IMMINGHAM EASTERN RO-RO TERMINAL

Environmental Statement Addendum

Document 10.3.8

November 2023

Figure 2.2. General Arrangement Plan showing Proposed Changes

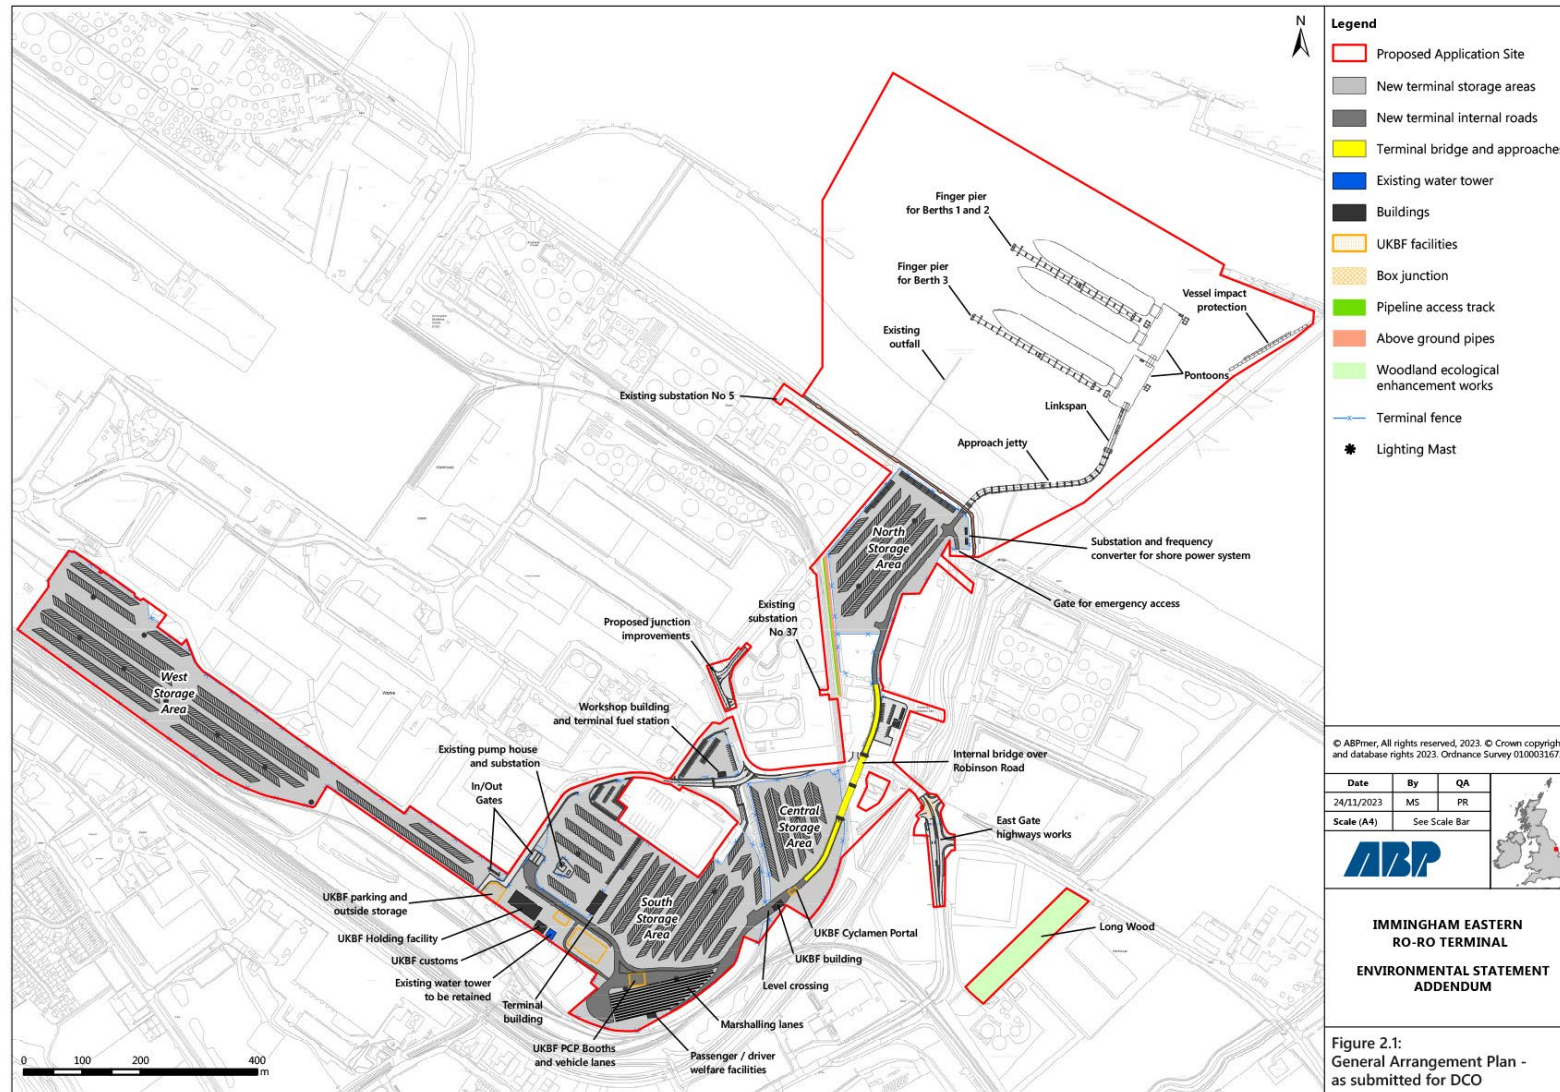
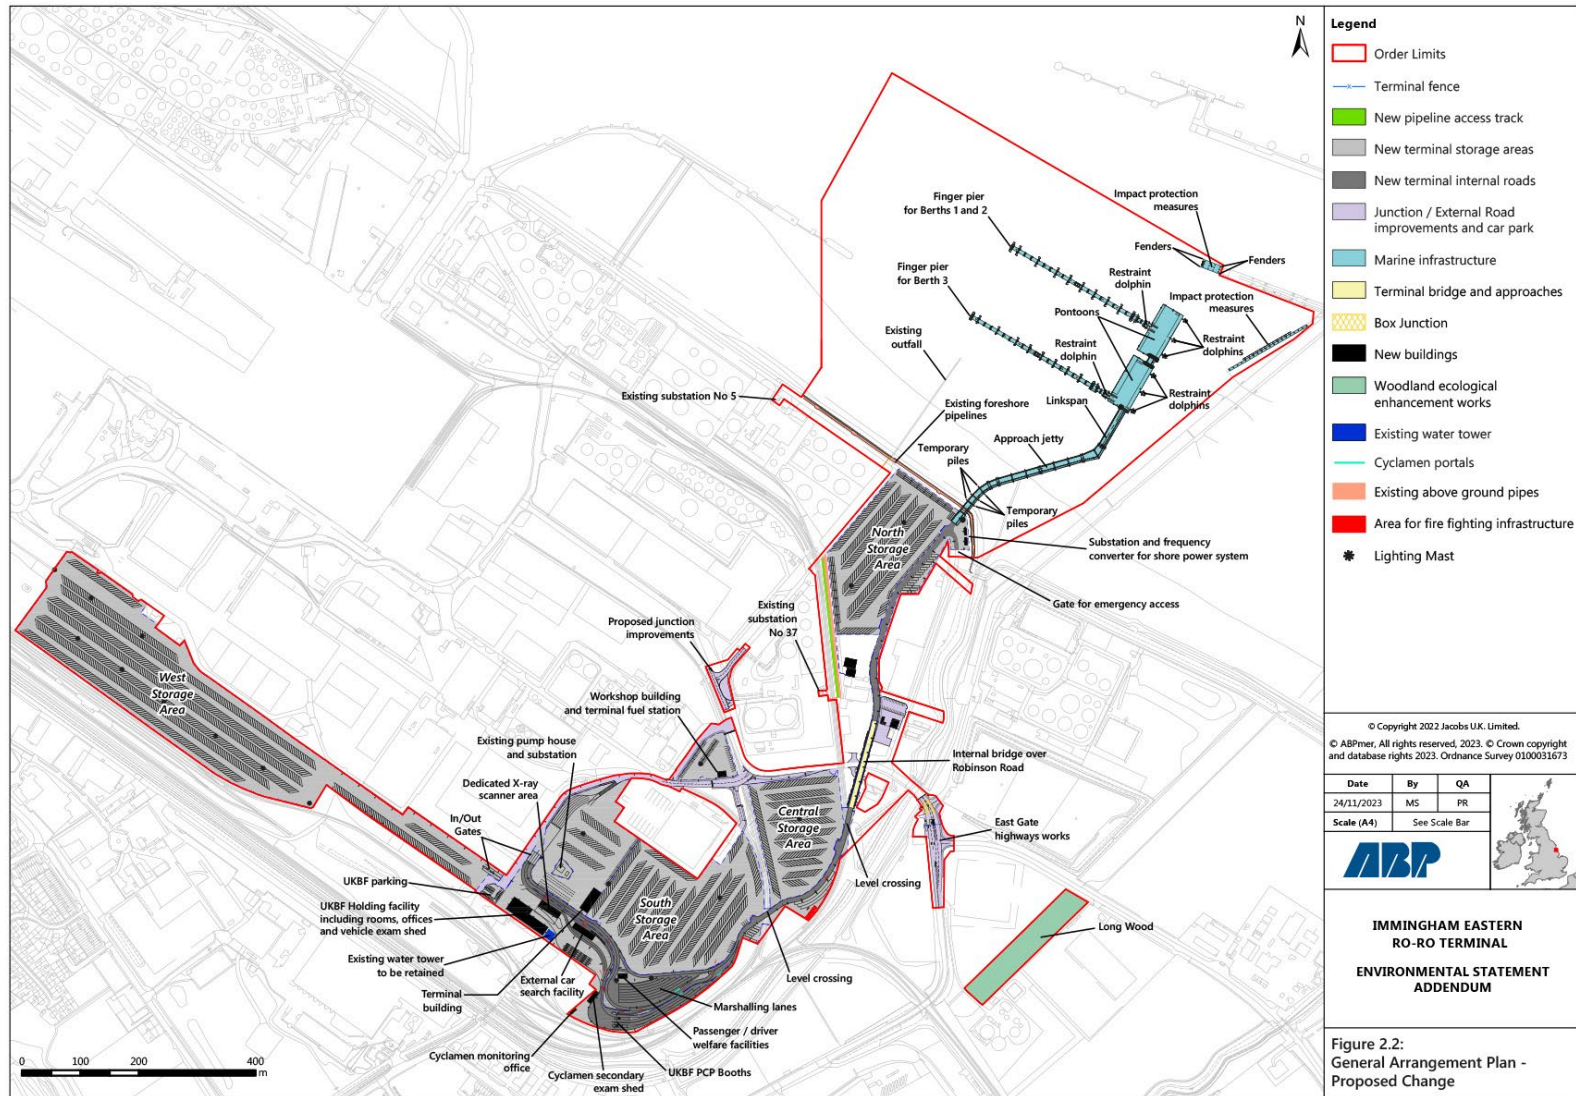
2.1.4 For ease of reference, Figure 2.1 shows the General Arrangement Plan as submitted for the DCO application. Figure 2.2 then shows the General Arrangement Plan with the Proposed Changes. This provides an update to Figure 1.3 of the ES [APP-059].

Figure 2.3. Proposed Change relating to marine infrastructure (Proposed Change 1 and Proposed Change 4)

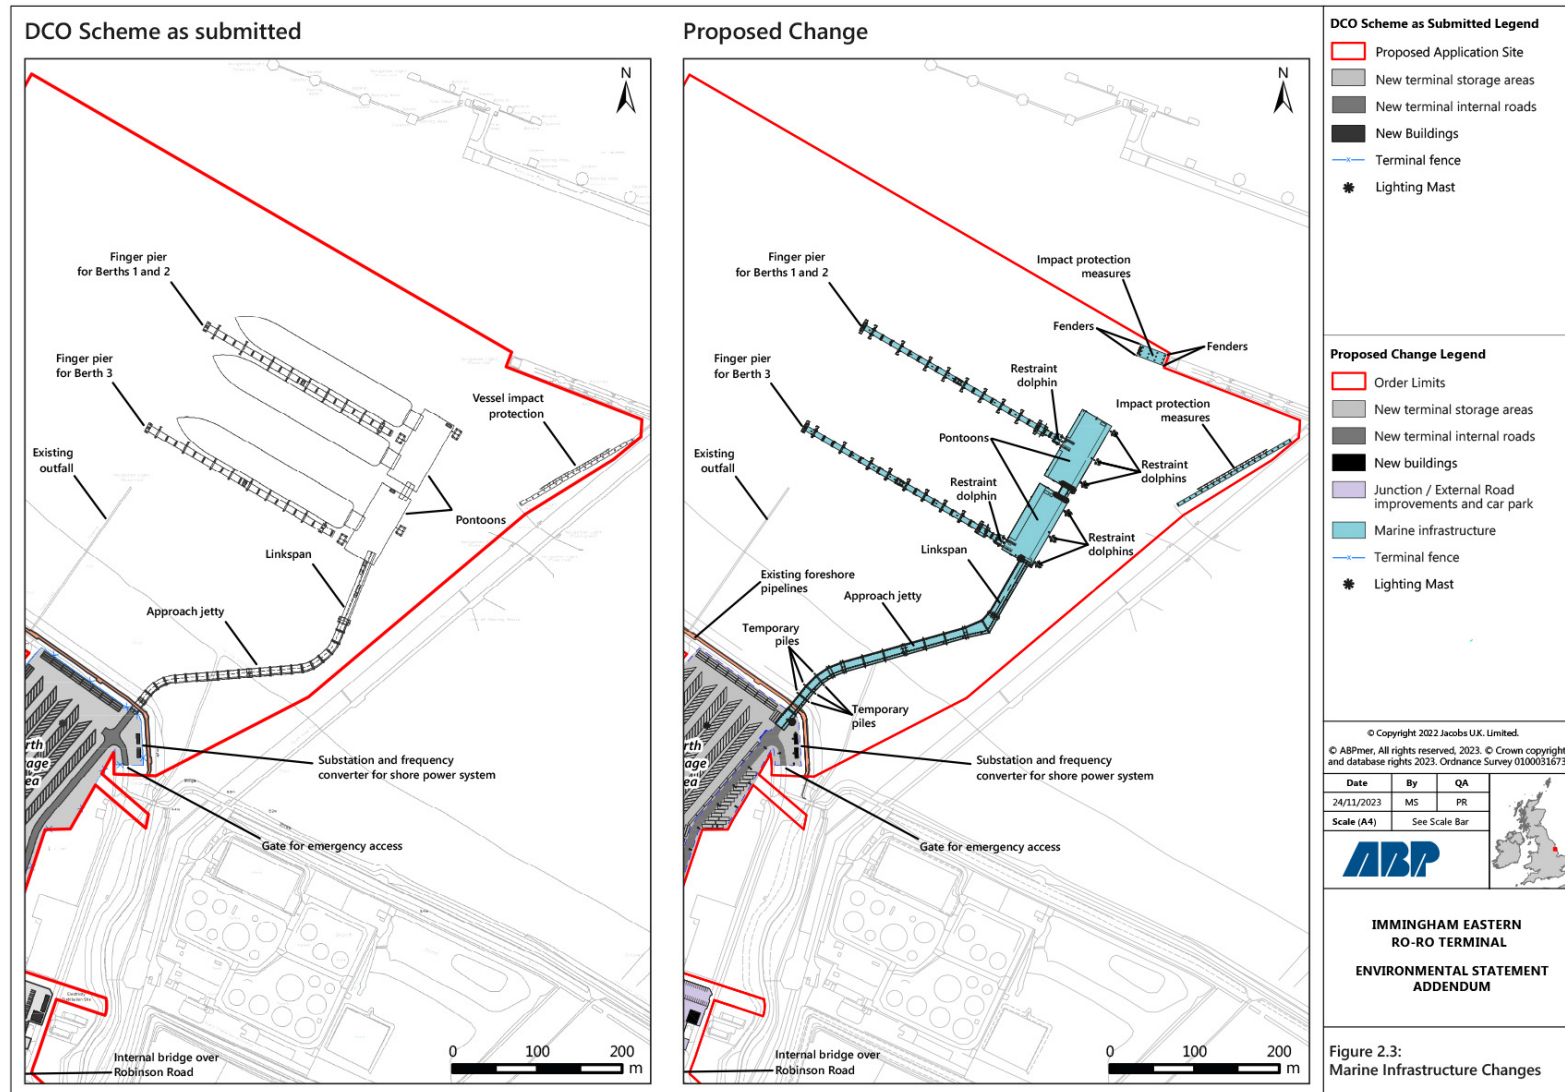
- 2.2.3 As part of the Proposed Changes, the approach jetty alignment has been straightened which moves the approach jetty away from Immingham Oil Terminal (IOT) marine infrastructure whilst still accommodating a suitable swept path for vehicular movement. A comparison of the alignments is shown in Figure 2.3. This provides an update to Figure 1.2 of the ES [APP-059].

- 2.2.11 Through a process of design refinement, the finger pier levels have been reduced to 10.9 m height above CD and an additional two piles have been also added to each of the finger piers to support mooring bollards and improve mooring performance. When constructed, each finger pier will now be supported by up to 56 piles.

- 2.5.3 It is proposed that the additional impact protection measures would consist of, if required, an impact protection structure at the western end of the IOT finger pier (see Figure 2.3). This will be in addition to the linear impact protection structure as originally described in paragraph 2.3.18 to 2.3.20 in Chapter 2 of the ES [APP-038] and included in Works Order no. 3 [APP-007]. The only change to the existing linear impact protection structure is that the pile diameter is proposed to be increased from 1,422 mm to 1,520 mm and filled with reinforced concrete or structural fill material.

Figure 2.4. Proposed Change 2: Realignment and shortening of the IERRT internal bridge

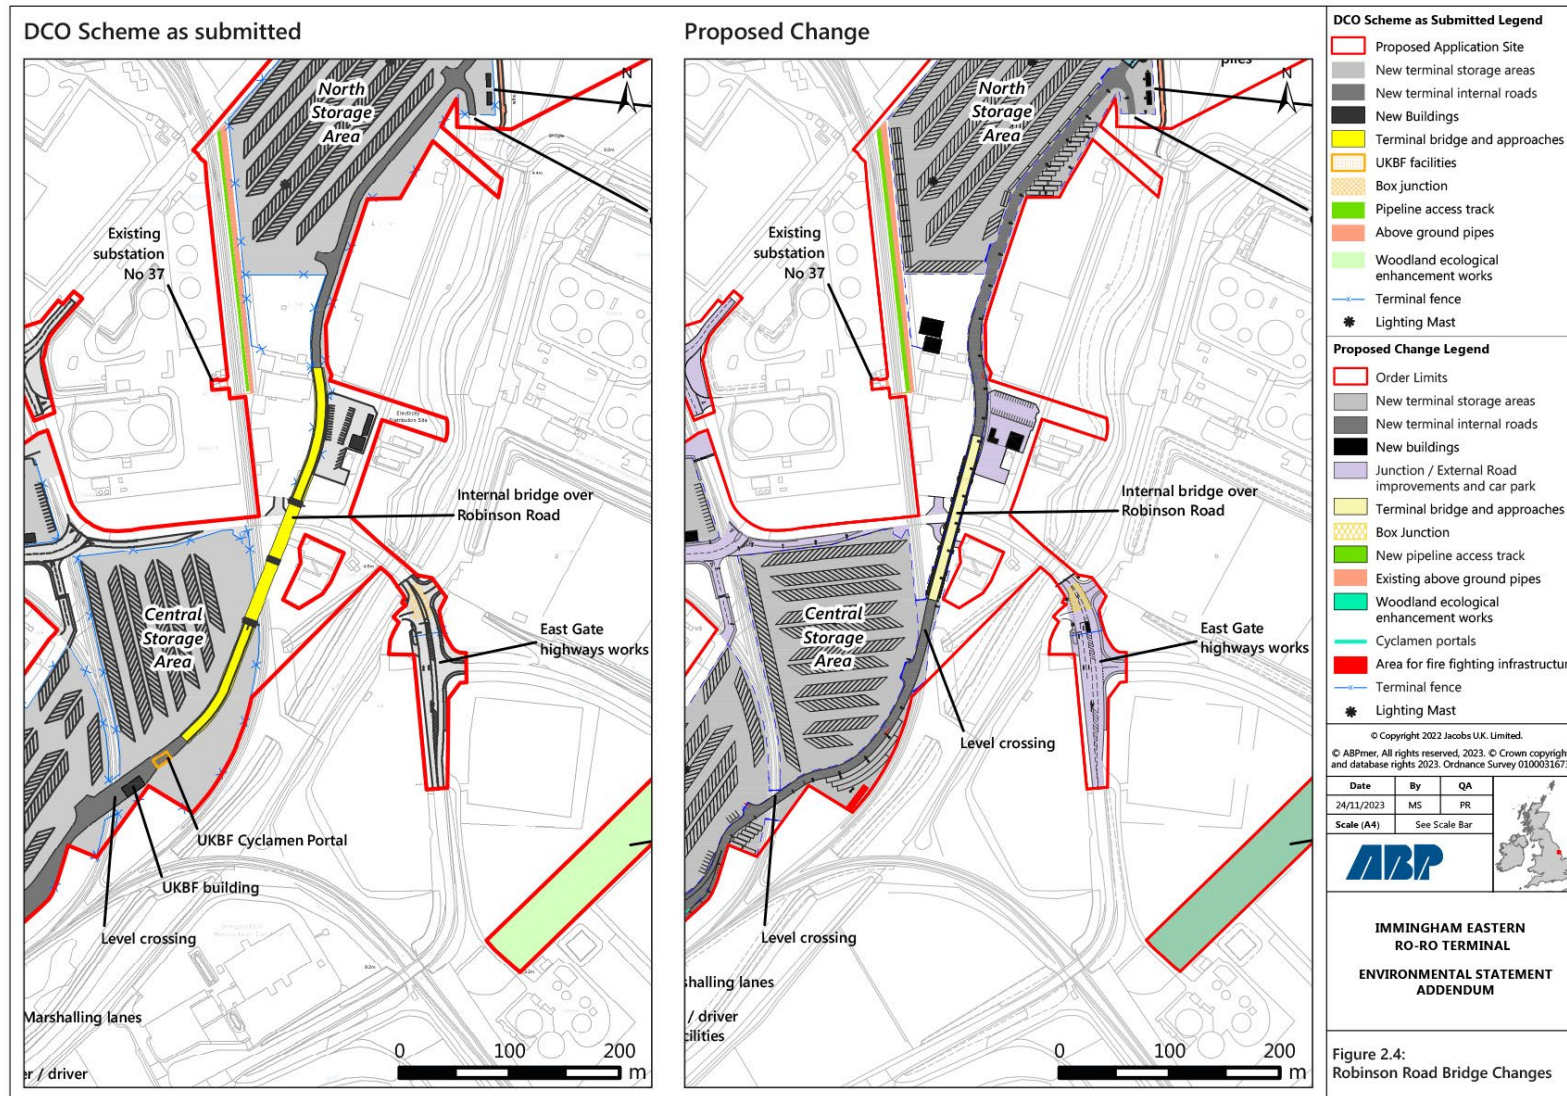
- 2.3.2 As part of the changes to the DCO application, it is proposed that this design is amended so that the bridge spans Robinson Road but not the ABP controlled railway spur line (Figure 2.4). The railway would instead be crossed via an at-grade (i.e., ground level) level crossing. The proposed bridge deck length has been shortened to 86 m. The maximum width of the bridge would not increase and there is no change to the maximum height of the bridge, being 11 m above the surrounding ground.

- 2.3.3 It is necessary to make a minor amendment to the alignment of the southern end of the bridge, moving the alignment eastwards requiring an amendment to the limit of deviation shown in Works Order no 7 [APP-007]. This is to ensure there is sufficient space for the bridge to cross the railway line at ground level.

Figure 2.5. Proposed Change 3: Rearrangement of the UK Border Force facilities

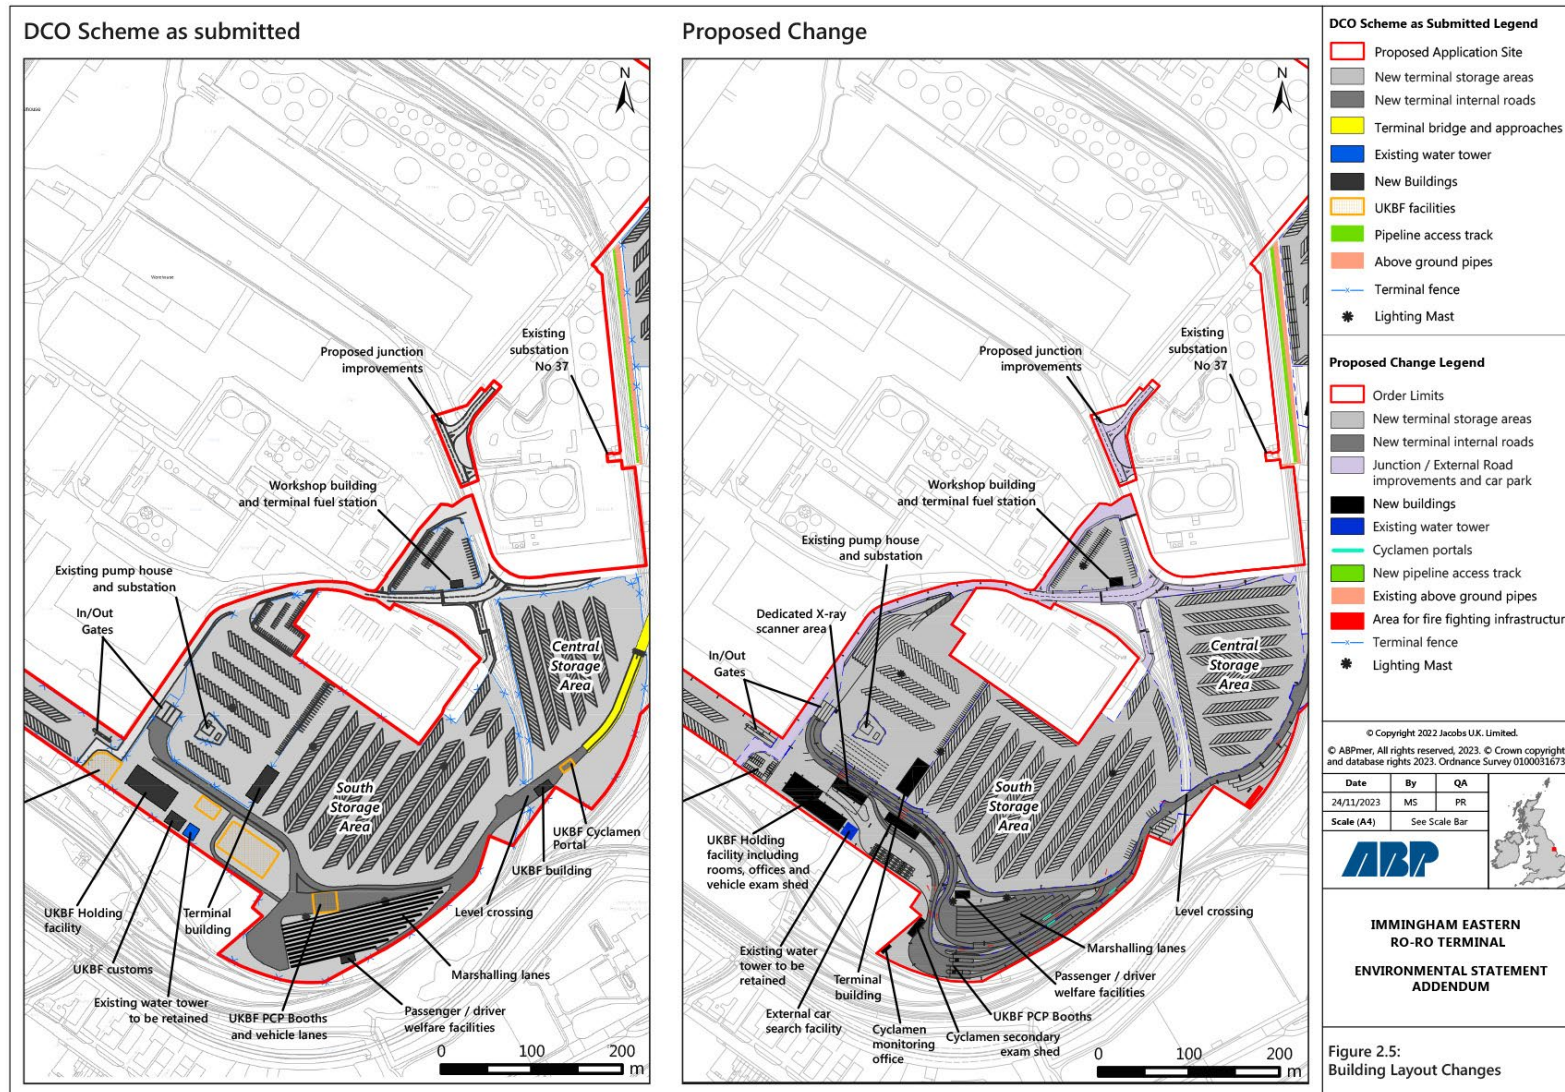
- Cyclamen Secondary Exam Building: A minor relocation of the building is proposed within the limits of deviation with no change in size;
 - Cyclamen Portals: A minor relocation of the previously shown portal closer to the UKBF buildings is proposed within the limits of deviation to improve operational efficiency with no change in size; and an additional portal to a bypass lane, required by UKBF for operational segregation of domestic and international traffic and security; and

- Passport Control Booths: A minor relocation of the building is proposed within the limits of deviation with no change in size.
- 2.4.4 In consultation with UKBF, changes are also proposed to the operational layout. The inbound road and associated passport control booth (noted above) have been moved to the southern boundary requiring the shift of the marshalling lanes to move slightly northwards. Additionally, a new unaccompanied lane has been created between the passport control booth and the marshalling lanes to allow continues transit of unaccompanied freight and improve customs operations.

- 2.4.5 These changes are shown in Figure 2.5.

Figure 3.1. Demolition works associated with the Immingham Eastern Ro-Ro Terminal

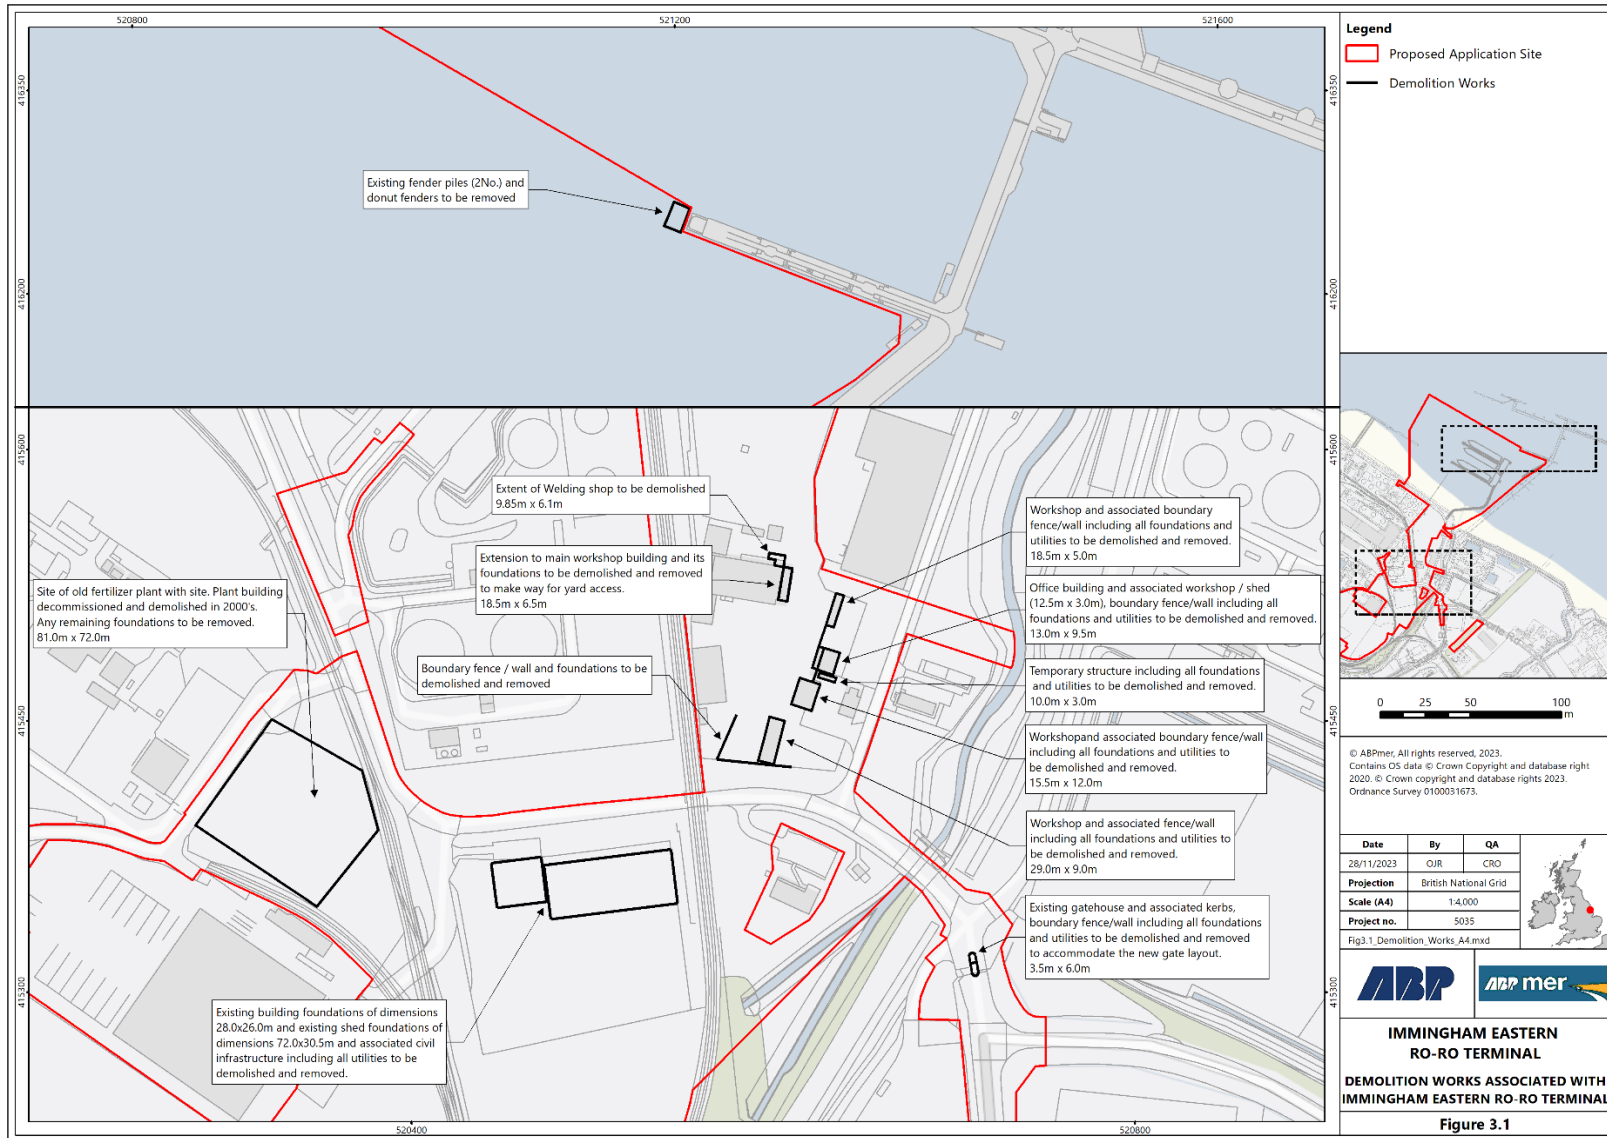
- 2.3.4 Paragraph 2.3.42 of Chapter 2 of the ES has been amended to include the demolition of a welding shop and the construction of two new structures for Drury Engineering Services Limited with a maximum size of 15 m x 13 m x 8 m and 20 m x 15 m x 8 m respectively. These are also shown at Figure 3.1 to this ESA.

- 3.4.1 Figure 3.1 of the ES [APP-061] requires updating following the Proposed Changes set out in Chapter 2 and Chapter 3 of this ESA. This is provided at the end of this chapter and is referred to as Figure 3.1.
